APPLICATION FOR VARIANCE

15-05-2

Name of project	State project number	County
St. Raphael church	na	Dubois
Address of site (number and street, city, state, and ZIP code)		
5546 E Raphae St. Dubois, IN 47527		
Type of project		
<input type="checkbox"/> New <input type="checkbox"/> Addition <input type="checkbox"/> Alteration <input type="checkbox"/> Change of occupancy <input checked="" type="checkbox"/> Existing

A. INITIAL RELEASE	TOLERANCES: DIMENSIONAL ±1/16"	ANGULAR ±0.5°	UNITS: INCHES	12/04/14	RF
REV. SCALE: NTS	PROJECTION:		DATE	DRN. BY	CHK. BY
XPRESS II FABRICATION DRAWING			63690-FI-A		
ST. RAPHAEL			PAGE 2 OF 4		
5564 E RAPHAEL ST.			MIDWEST ACCESSIBILITY PRODUCTS (OH)		
DUBOIS IN 47527

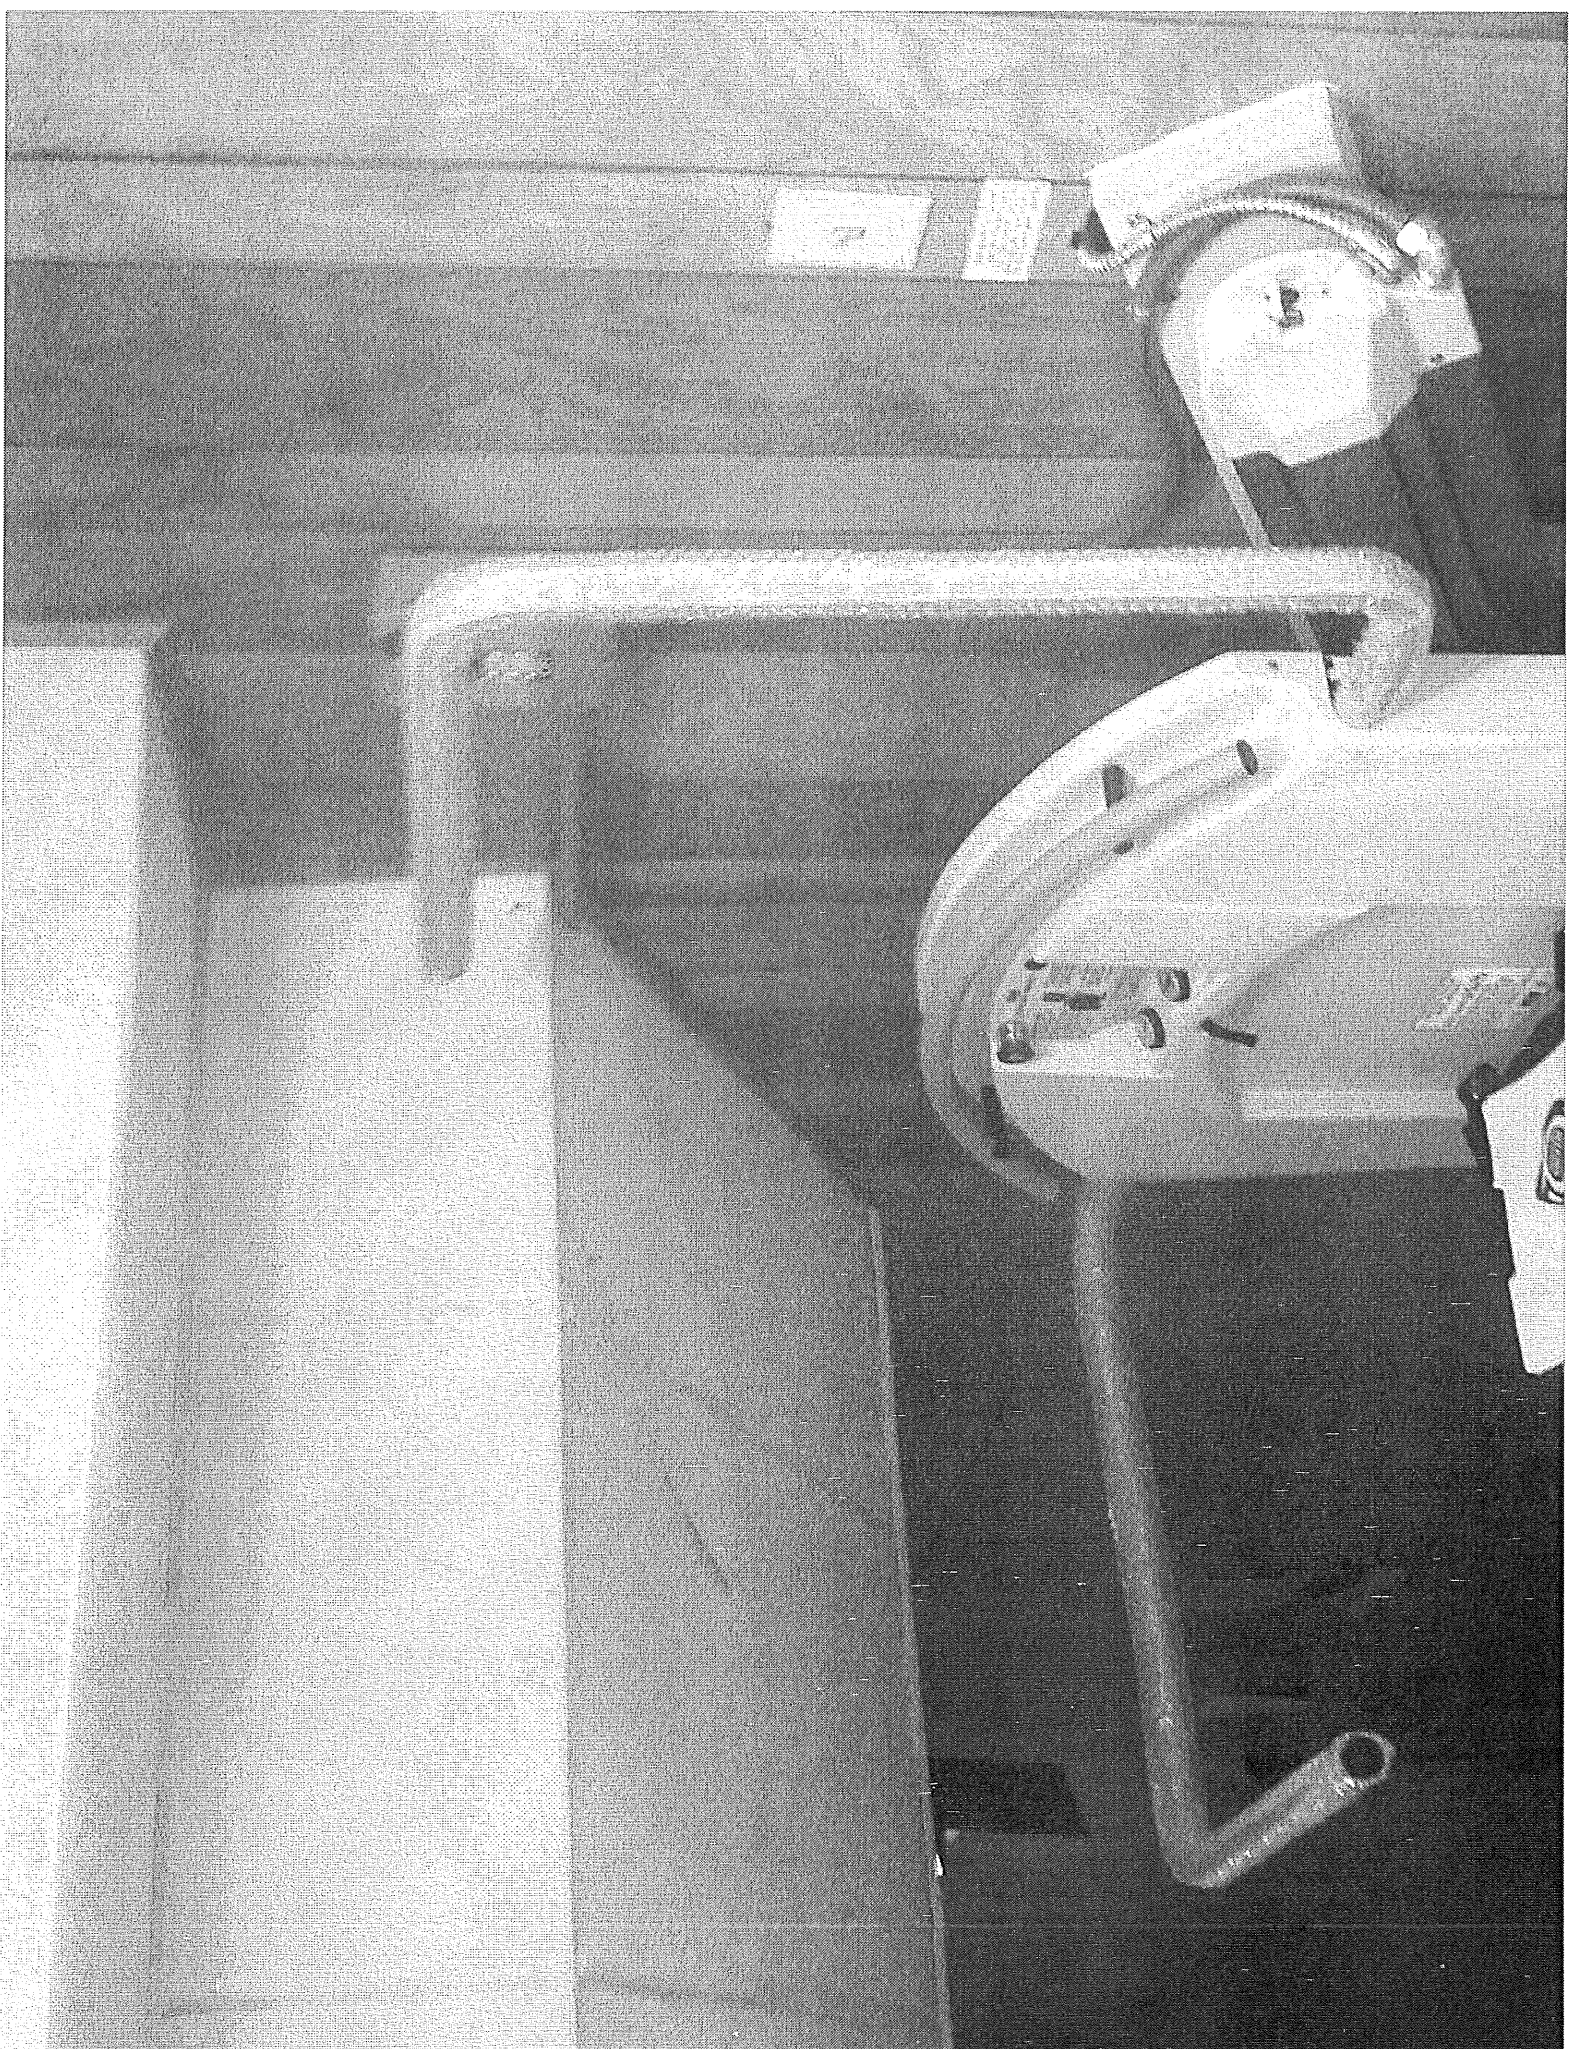
3.1.2.1 requires 80" overhead above platform. we have 84" at top and 50" at lower end of platform and 71.5" at seat area.. 3.1.2.2 headroom clearance shall be 60" during travel. During travel overhead lowest spot is 50" and once it clears beam area overhead is within code.

There is a structural beam in ceiling above stairs which supports upper level above stairway. The cost of construction and design would be to excessive for church. They are just wanting to be able to get someone in a wheelchair to lower meeting area for church functions.

We will install signs warning low overhead and please be seated at upper and lower landings. There is a fold down seat on platform and a attendant remote for customer to operate lift while passenger is riding if needed. We will also put padding over low overhead area affected and more signage warning of low overhead. Customer will alter drop ceiling to creat as much overhead as possible up to beam.
